Site Plan Review Committee (SPRC)
Staff Report for
4600 Fairfax Drive (Ballston Holiday Inn)
SPLN21-00008 (SP #57)

4600 Fairfax Drive (SPLN21-00008)
Ballston Holiday Inn Site
(RPC#s 14-053-055, -056, -023, 14-054-020, and -008)

Proposed Site Layout:

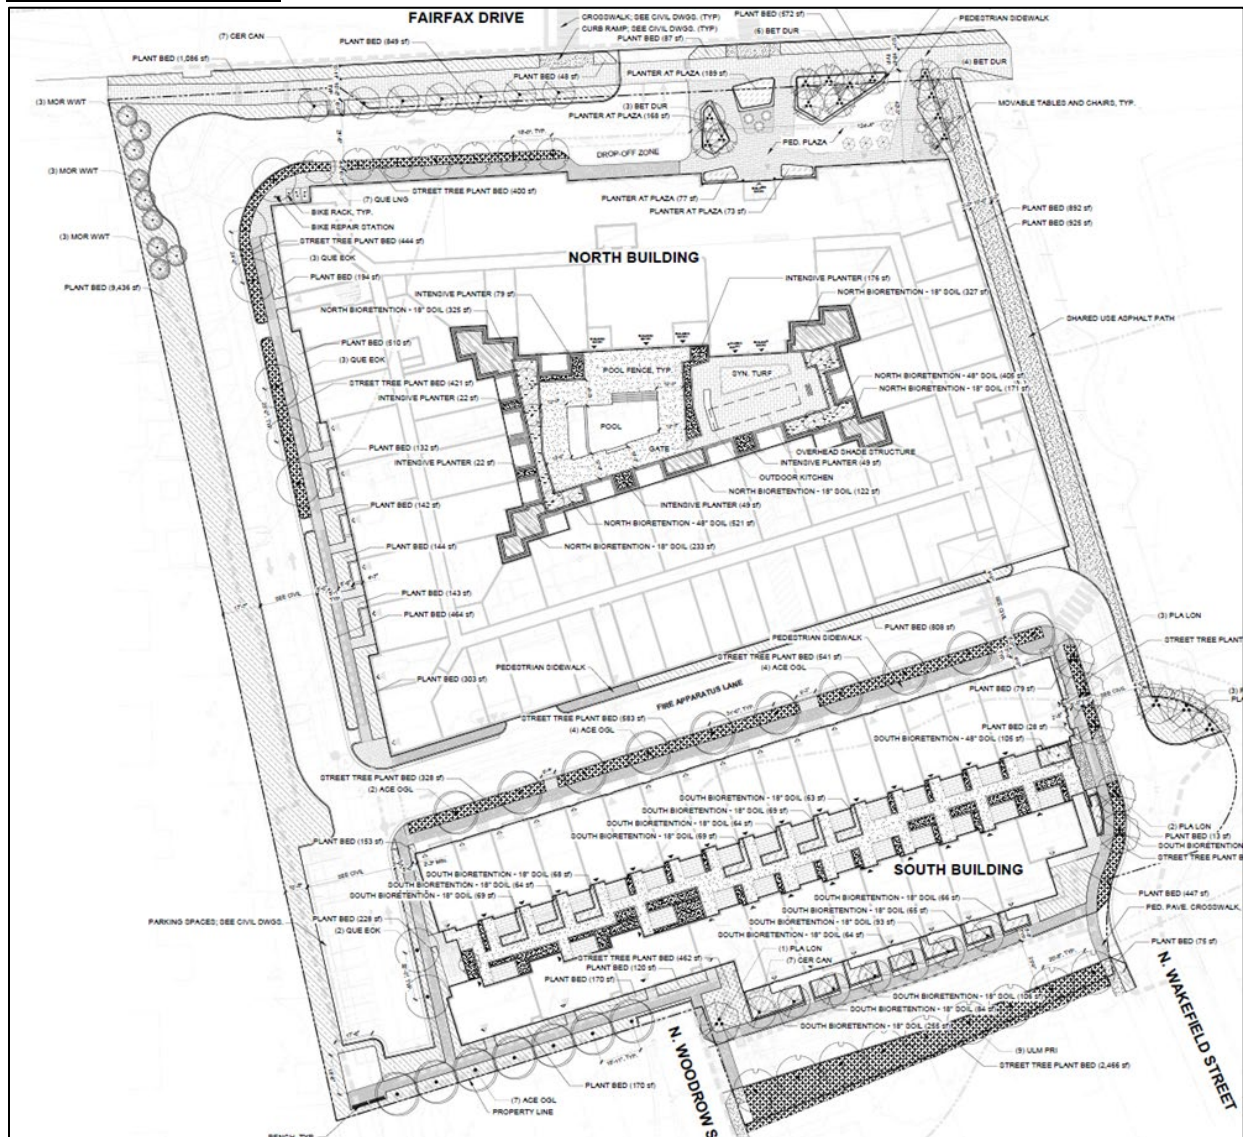
- The proposed auto-oriented, circuitous design detracts from maintaining and enhancing a grid-style street network, as identified by MTP Policy Goals. Providing more direct alignment, in conjunction with a complete streets design, could improve pedestrian and bicycle access and safety and reduce vehicular circulation within the site.

- The meandering service (or fire access) road and surface parking lot detract from reducing impermeable surface area, as identified by MTP Policy Goals.

- The proposed streetscapes are lacking standard, Local Street design features identified in the MTP Streets Element, such as sidewalks, trees, and on-street parking, in several locations

- The service road includes several 90-degree turns but lacks traffic control signs or markings

- Proposed removal of existing trees along the west and northern edges of the site detracts from creating a landscaped buffer recommended by the Sector Plan.
- Service road/surface parking proposed on the western edge of the property creates impervious area that could otherwise potentially be landscaped.

Proposed Floor Plans:

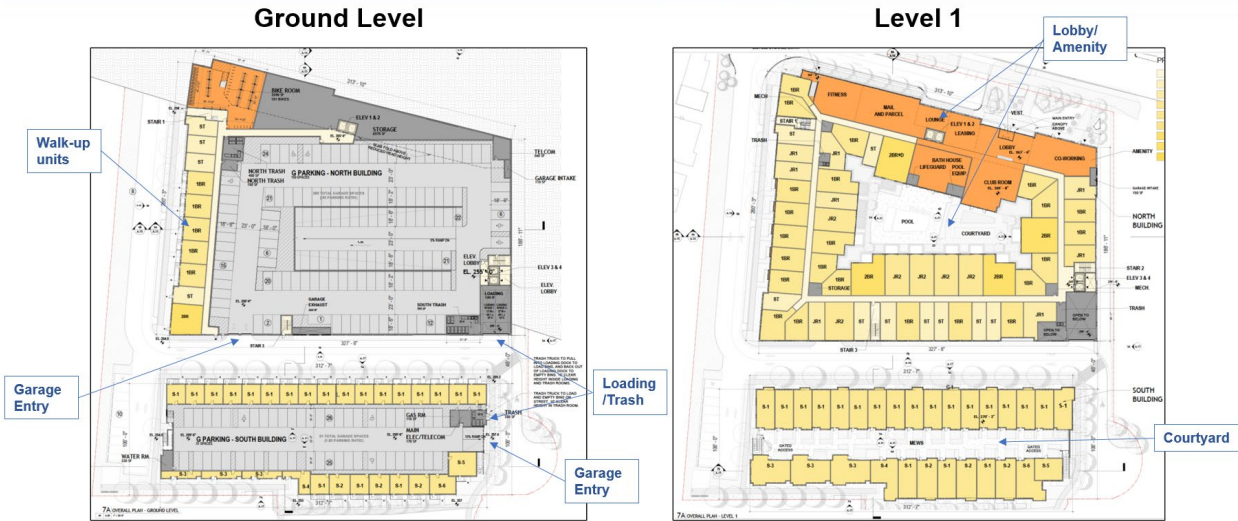
- The footprint of the North Building is significantly larger in scale than existing adjacent development. Reducing the building footprint or constructing two smaller buildings (in conjunction with a more direct or grid-style street layout) would provide a more pedestrian-oriented scale and design.

- Building height tapering along the western edge of the North Building, from tapering 7 stories down to approximately 5 stories, would better align with Sector Plan guidance.

- Active uses, such as dwelling units or residential amenity space, should be explored/added to the south side of the North Building, facing the South Building. The current proposal includes a ground level parking garage with little fenestration or pedestrian-oriented design elements.

- Off-street loading and trash locations create potential conflicts with other vehicles, cyclists, and pedestrians. Off-street loading space for the South Building should be explored to prevent trash removal and loading activity from occurring in the street/access road.
